17923 SNUG HARBOR RD

Groundwater & Wastewater Services
Septic Project File & Data Review Worksheet

GWS File #: 5719B WASPS App #: 3272

APPLICATION FOR APPROVAL TO USE AN EXISTING ON-SITE WASTEWATER TREATMENT & DISPOSAL SYSTEM
MECKLENBURG COUNTY - GROUNDWATER & WASTEWATER SERVICES
700 N. Tryon St., Suite 211 Charlotte, NC 28202
Phone: (704) 336-5103 Fax: (704) 336-6894

PROPOSED PLOT PLAN

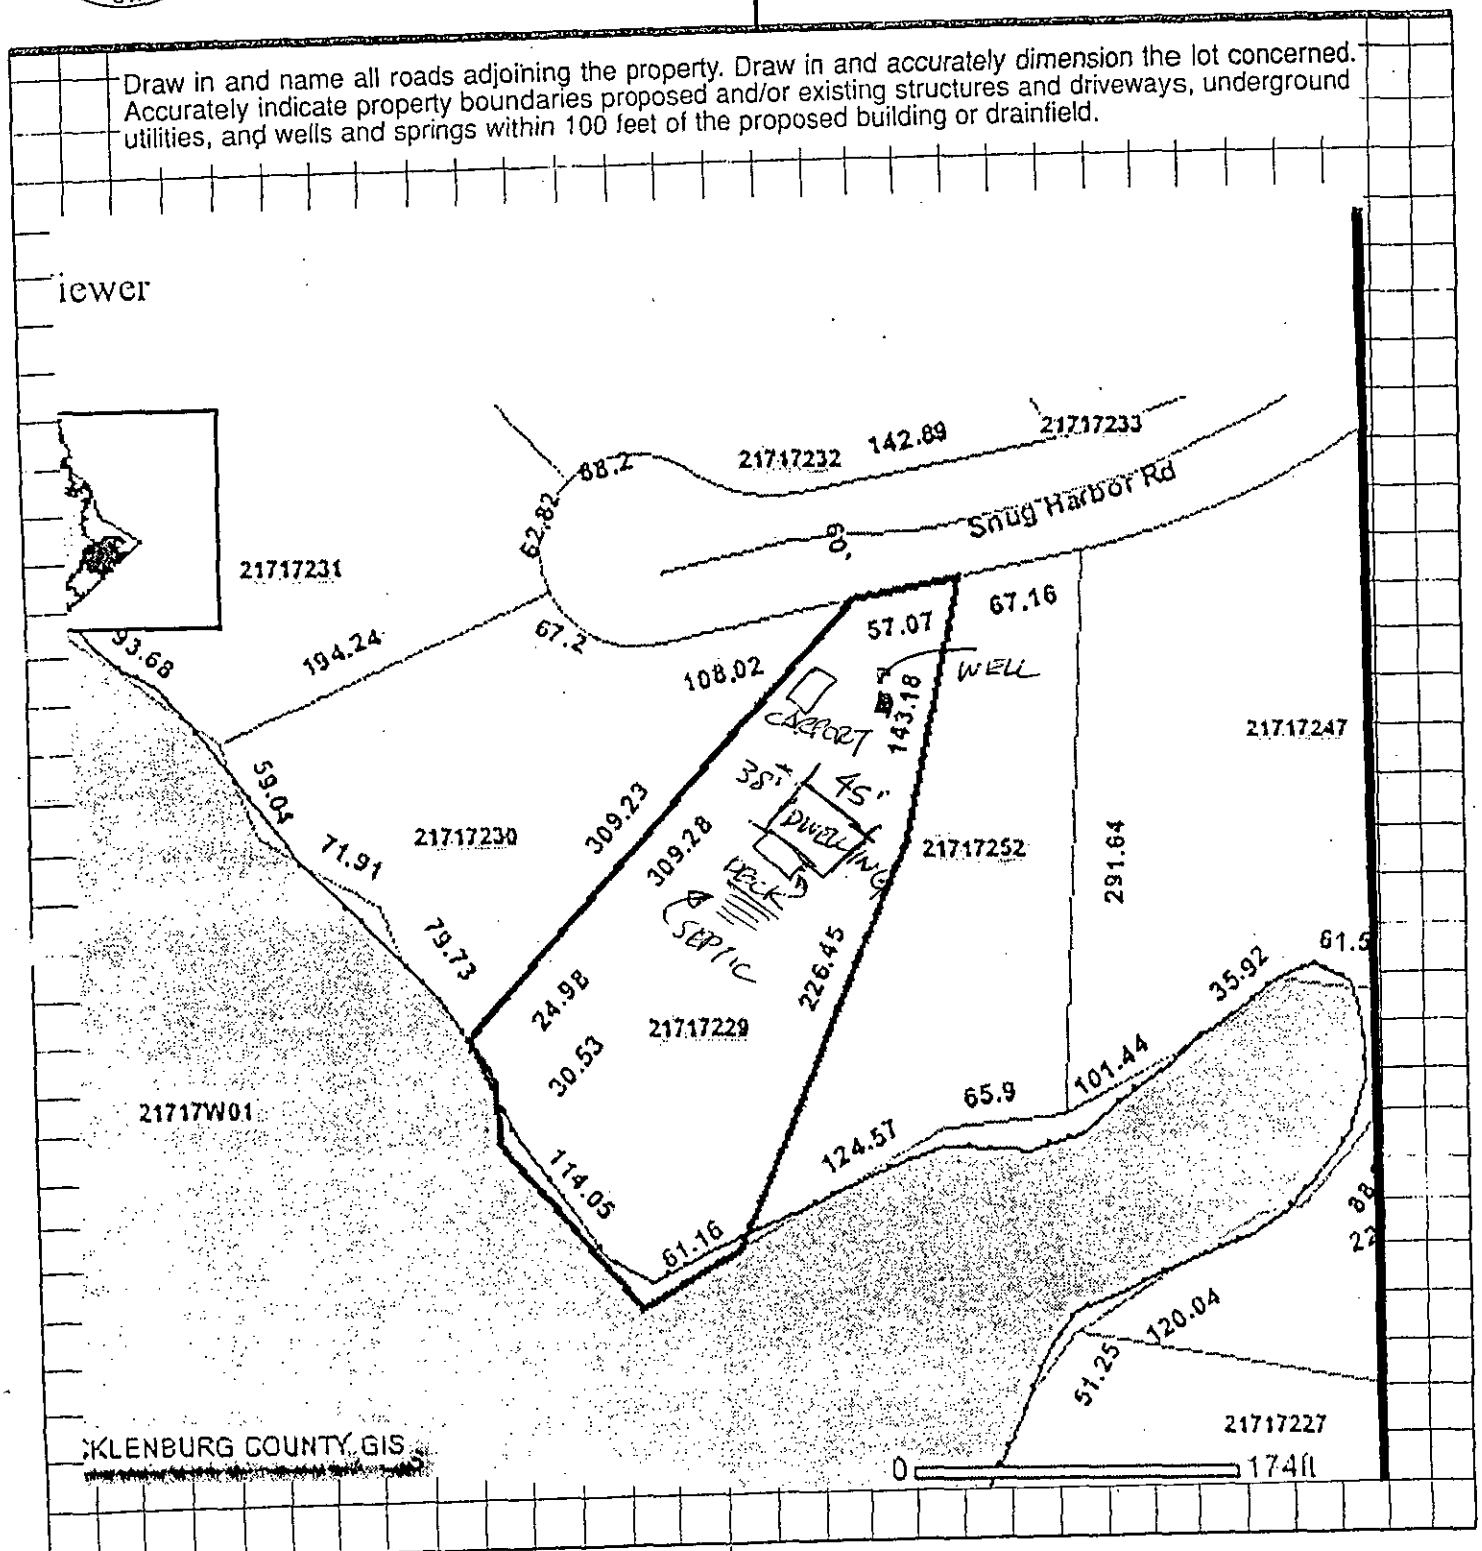
O.K. TO REPLACE EXISTING HOUSE WITH A 3 BEDROOM HOUSE. DISTANCE FROM DRAINFIELD MUST REMAIN THE SAME

PROPOSED PLOT PLAN

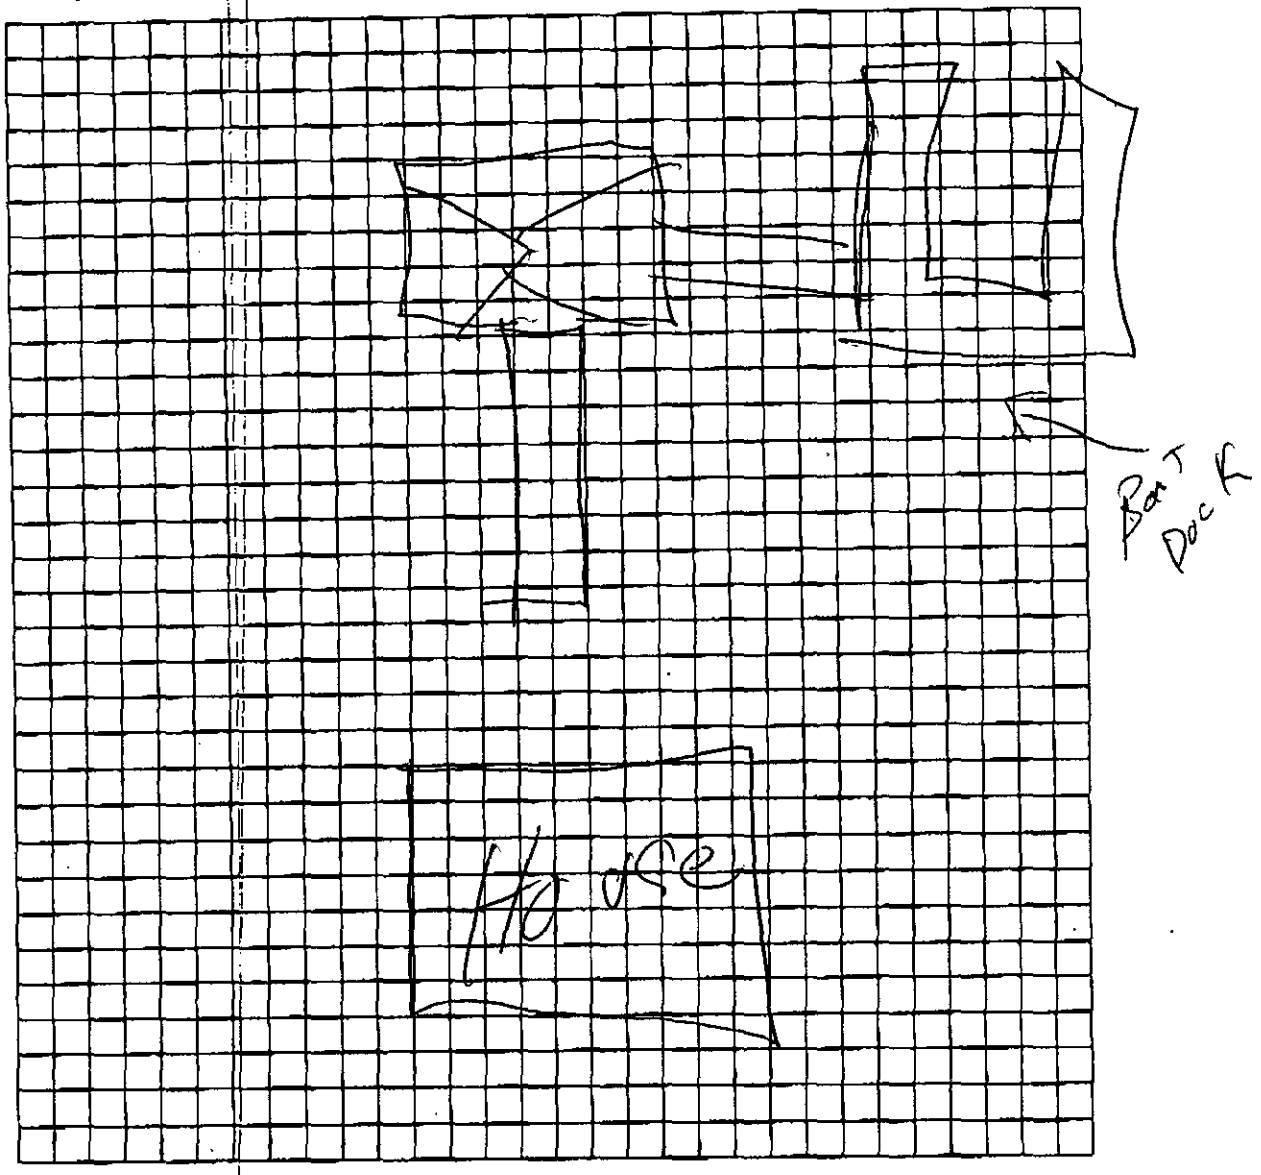
Use existing system for construction of boat dock
System denied due to 4'x92' walkway built over
drainfield.

Charles Zinn 2/19/08
USE EXISTING DENIED
Christopher M Stewart 3/4/08
EHS Signature Date

- ☐ The existing on-site wastewater treatment & disposal system was not functioning properly at the time the site evaluation was conducted.
- ☒ The proposed plans do not meet the required setbacks for the on-site wastewater treatment & disposal system serving the property.
- ☐ The proposed plans do not meet the required setbacks for the reserved repair area for an on-site wastewater treatment & disposal system.
- ☐ The proposed plans do not meet the required setbacks for water supply wells.
- ☐ The proposed project will exceed the permitted daily design flow for the existing on-site wastewater treatment & disposal system. System alteration will be required in order to accommodate your proposed project.
